926 North Beverly Drive

STAFF REPORT
CITY OF BEVERLY HILLS

SUBJECT: A request for an R-1 Design Review Permit to allow the construction of a new two-story single-family residence, located in the Central Area of the City, north of Santa Monica Boulevard at **926 North Beverly Drive.** (PL#102 0001)

Elevation - 9/2/10

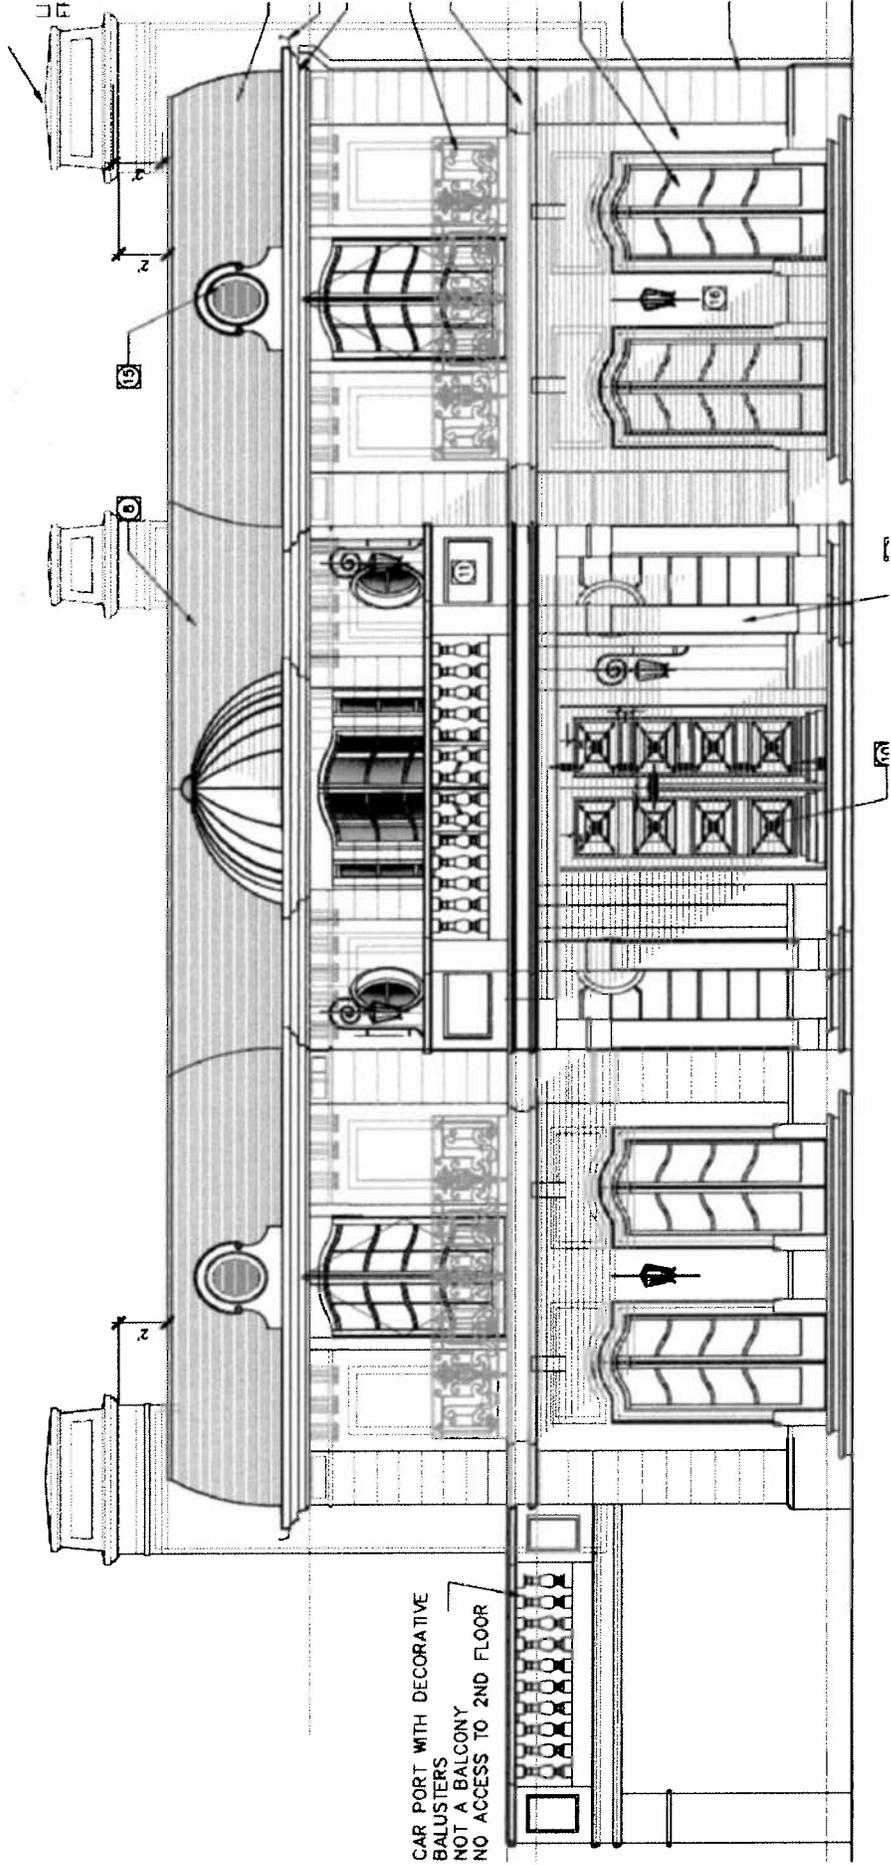
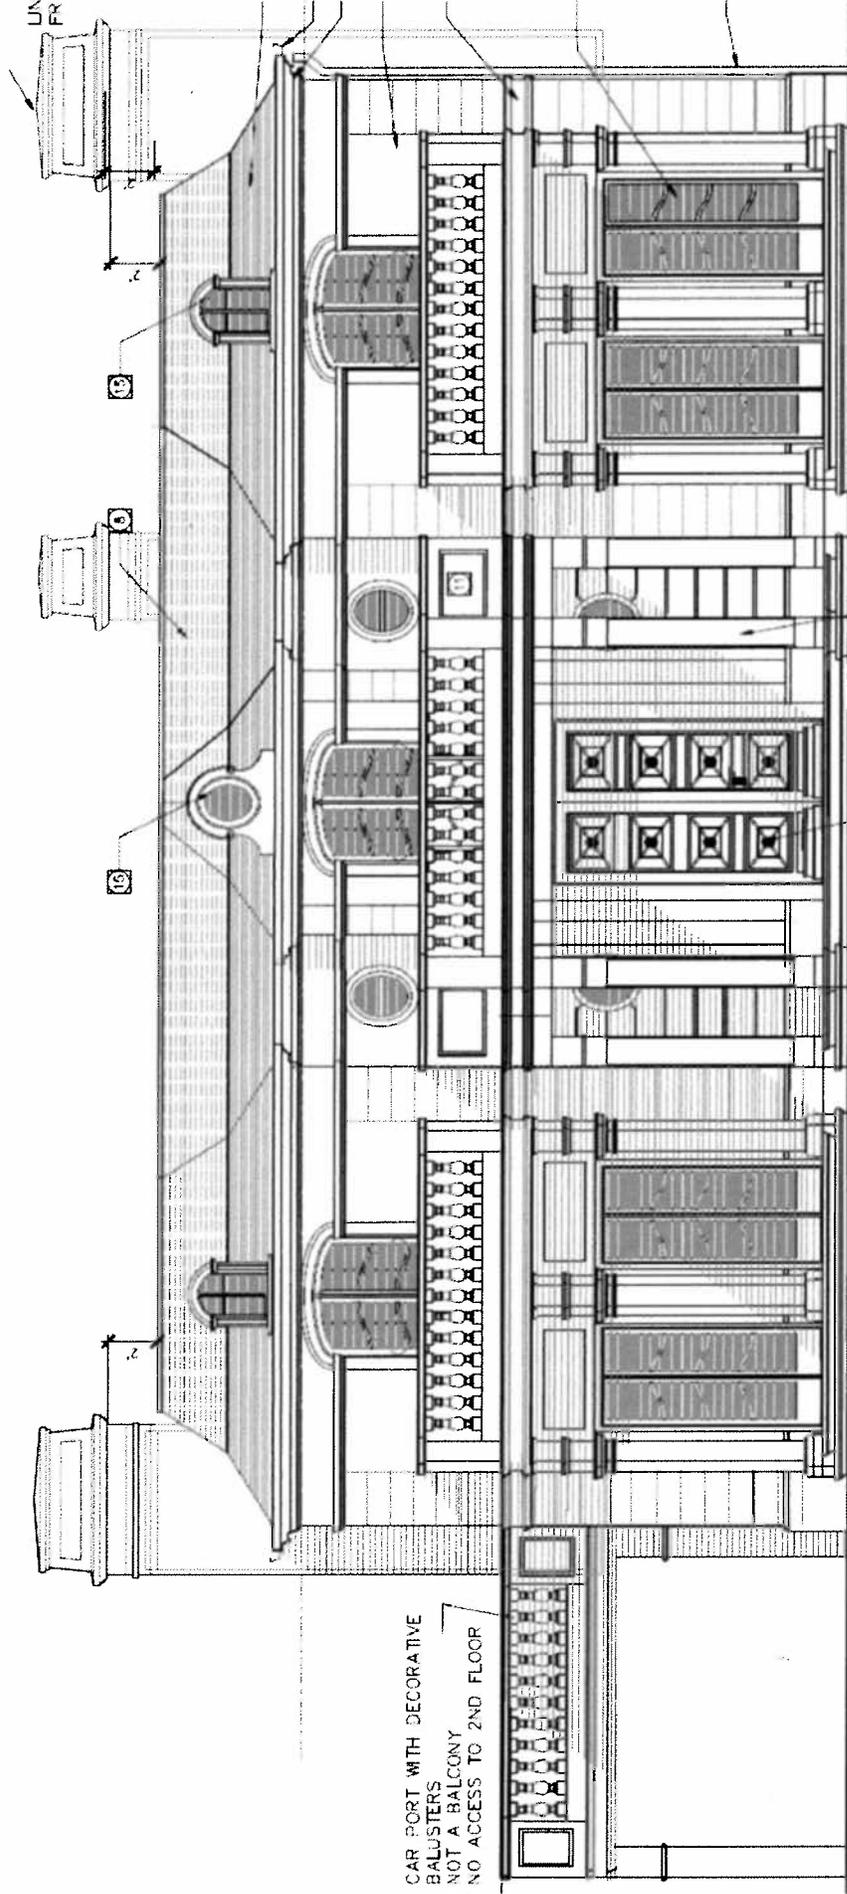
CAR PORT WITH DECORATIVE
BALUSTERS
NOT A BALCONY
NO ACCESS TO 2ND FLOOR

Revised Design

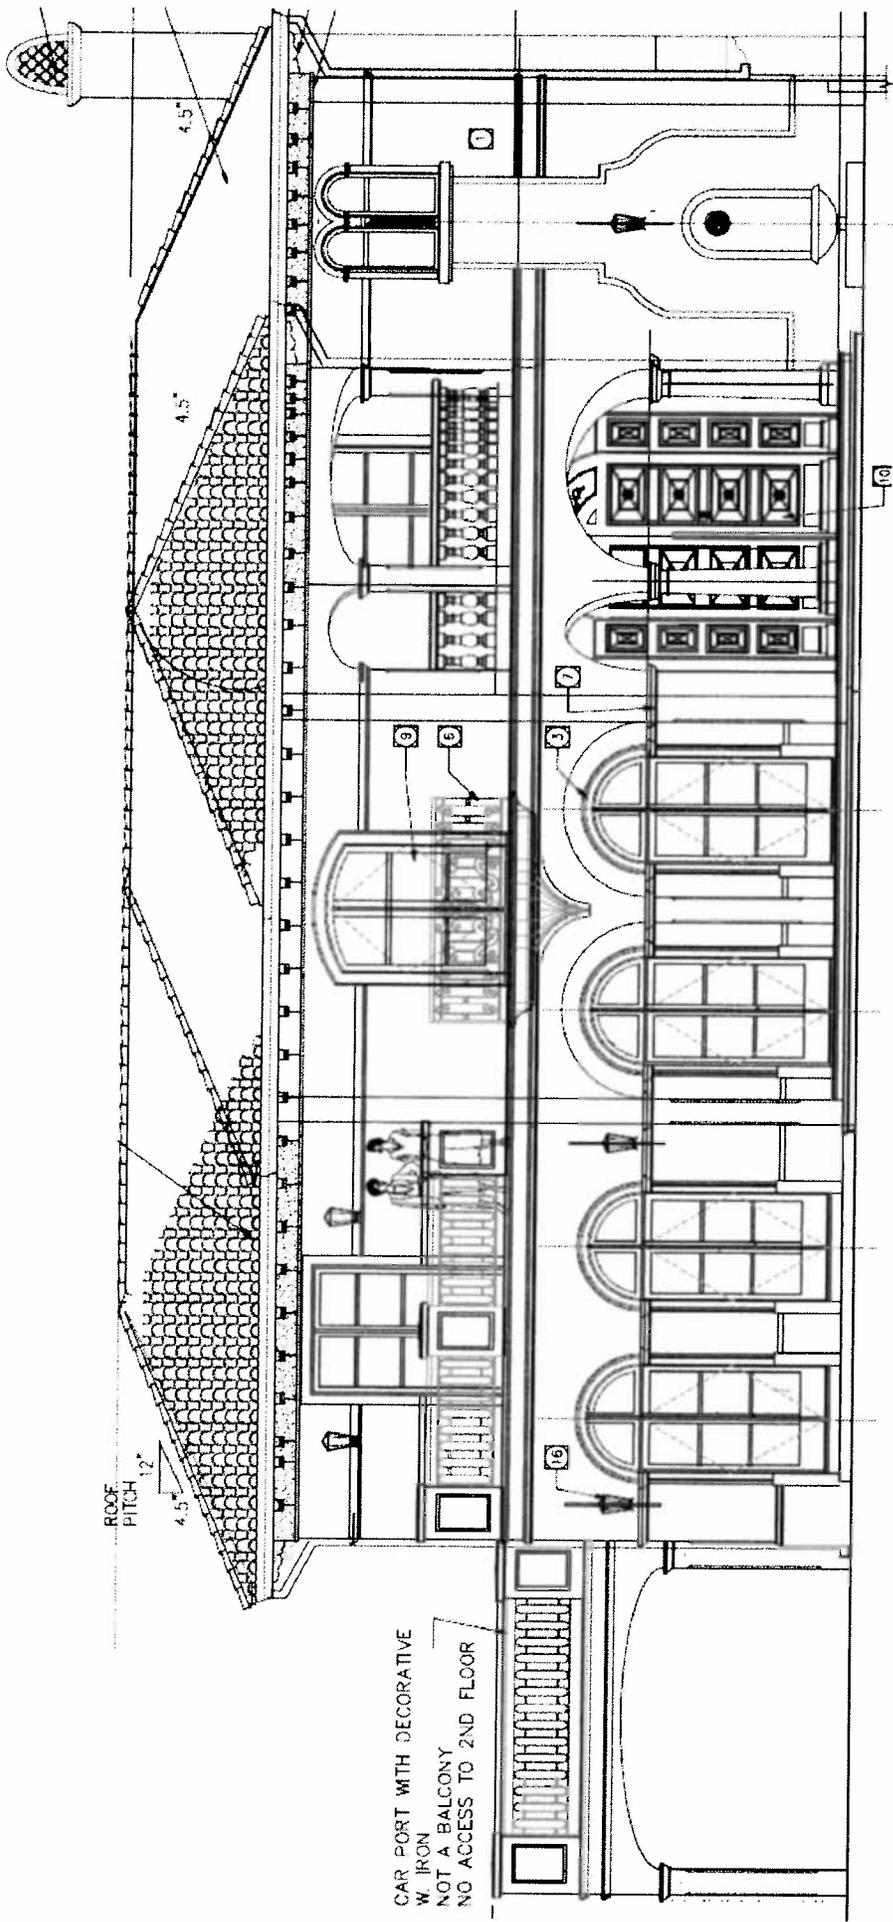
After providing the comments above, the Commission expressed concern with being responsible for picking a design option for the applicant. The Commission directed the applicant to choose an architectural style and provide a design that is consistent with that style of architecture. The applicant then stated that their preferred design was Option #2, and thus the majority of the Commission's comments were directed toward Option #2. Since the November 4, 2010 meeting, the property owner has expressed the desire to move forward with a re-design of Option #1. As a result, the applicant is returning to the Commission with a revised design of Option #1, not Option #2. The applicant has made the following changes to the Option #1 design:

- The façade design is now symmetric, with the exception of the porte cochere along the northern side of the residence;
- The tower-like elements flanking the central entry have been recessed and the rooftops to these elements have been removed. Two rounded windows have been added at the second story of these recessed portions of the façade;
- The second story colonnades have been removed;
- The second story balconies at both sides of the central entry element have been reduced in size and now just wrap around the two sets of French doors;
- The balcony above the front entry has been redesigned;
- The wrought iron railings have been simplified on the balconies;
- The wrought iron fence has been simplified;
- The roofline has been redesigned;
- A stone veneer is being proposed on the entire central portion of the façade.

Proposed Option #1

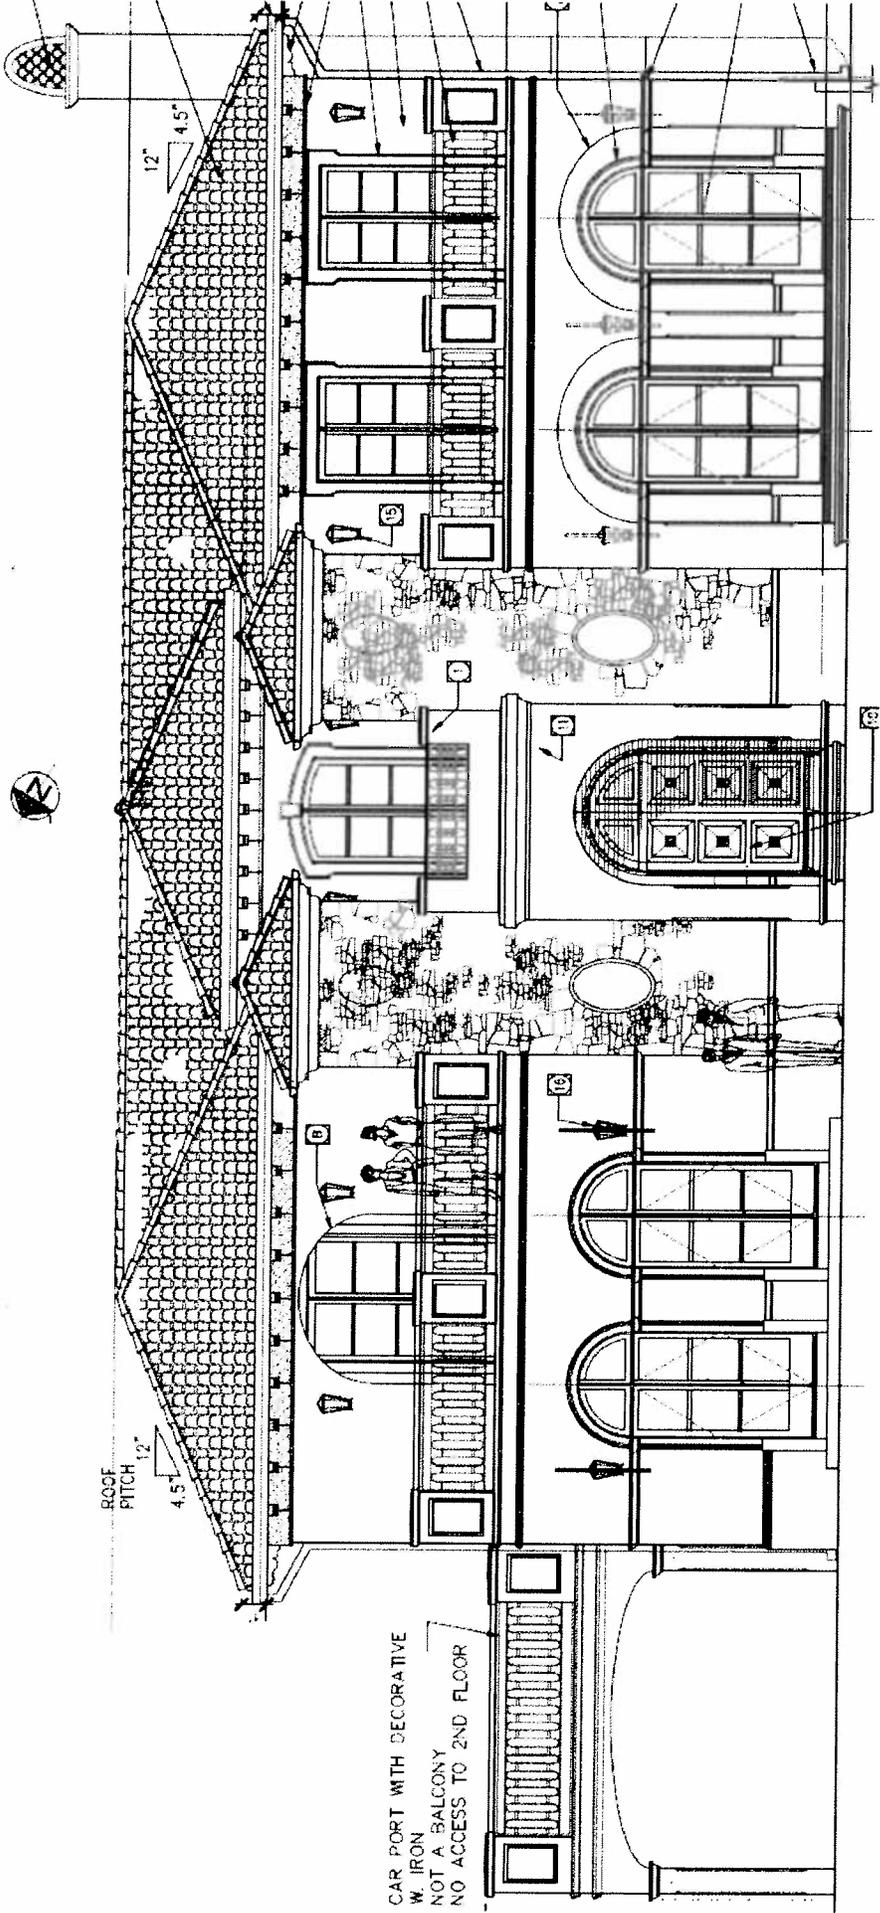
Option #1:

- The design is bulky, heavy and fortress-like
- The design very closely resembles 519 N. Beverly Drive
- Pedestals are out of proportion
- Provide a consistent front yard fence design (inconsistent between the landscape plan, L-1 and the elevation, A-01).
- Provide accurate plans (sketches are not accurate)

Proposed Option #2

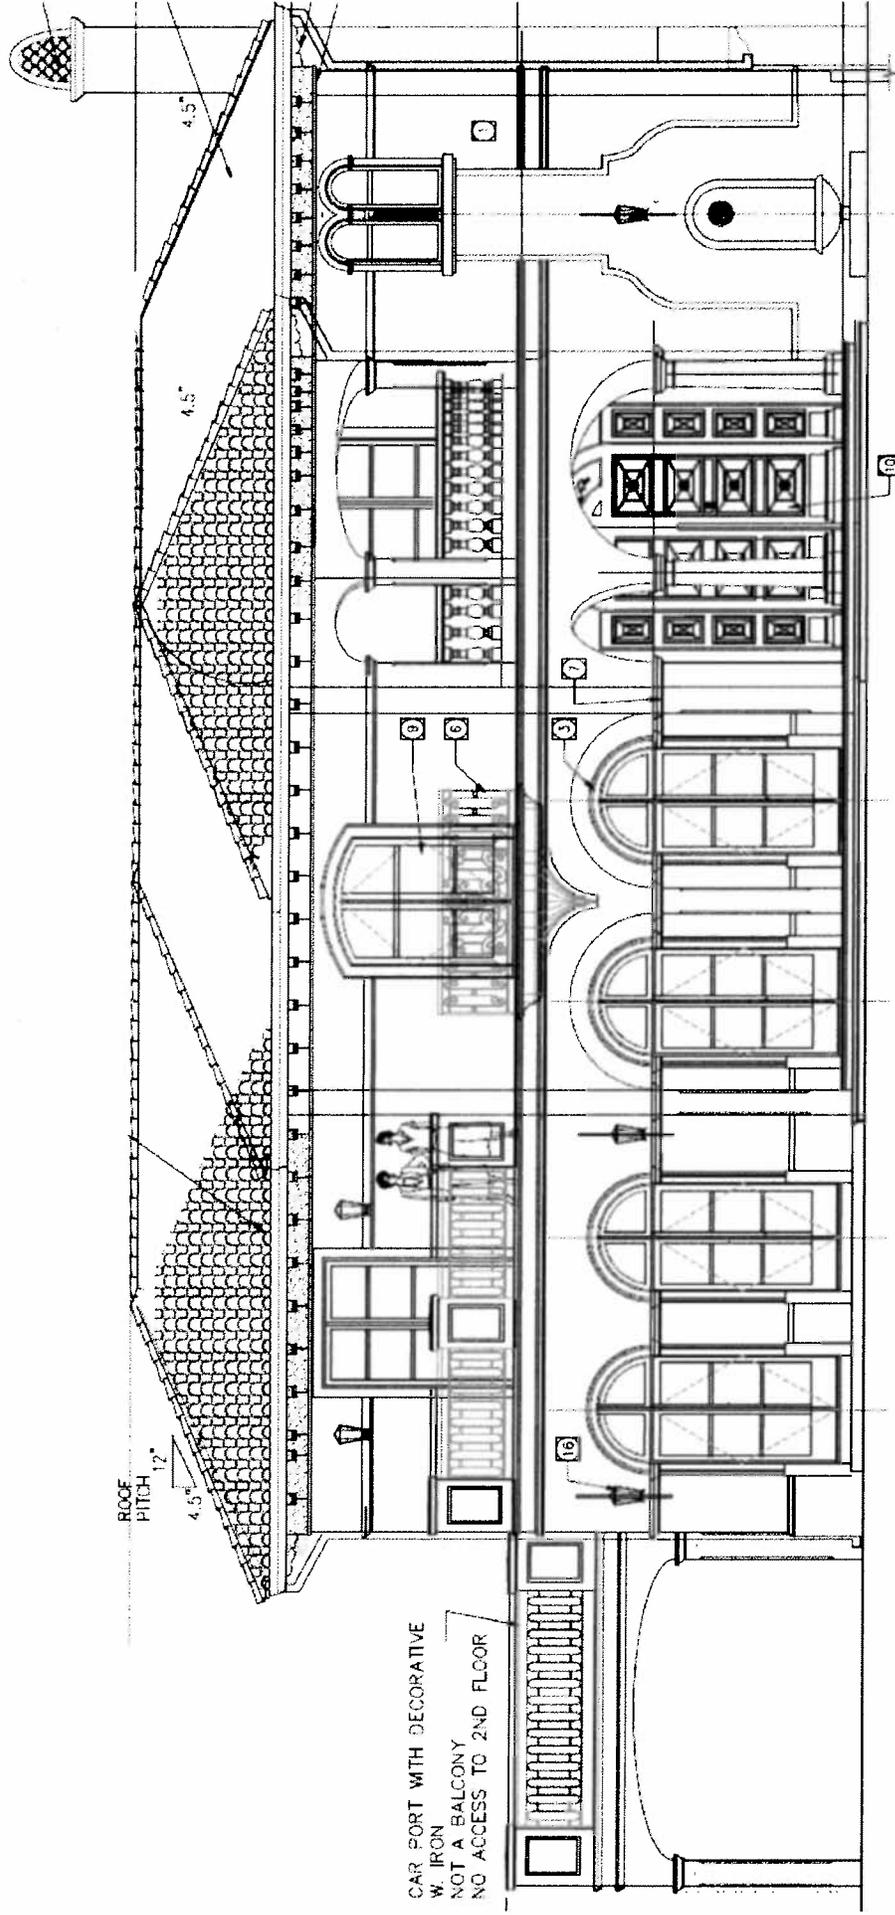
Option #2 (this was the applicant's preferred option):

- Certain elements are consistent with Spanish style architecture, but the design is not a consistent style overall. Add elements which are more consistent with the Spanish style of architecture.
- Rotunda is out of place, feels forced and heavy
- Consider a traditional "L-Shape" Spanish design which could incorporate a courtyard and balconies
- Consider a covered walkway to the recessed entrance

- Landscape plan needs to be more informal and align with the axis of the entrance
- Design is too busy – there are too many different styles of elements including the arches, railings, windows, etc.
- Design is too massive for the property – belongs on a longer lot
- Provide a consistent front yard fence design (inconsistent between the landscape plan, L-1 and the elevation, A-01)
- Provide accurate plans (sketches are not accurate)
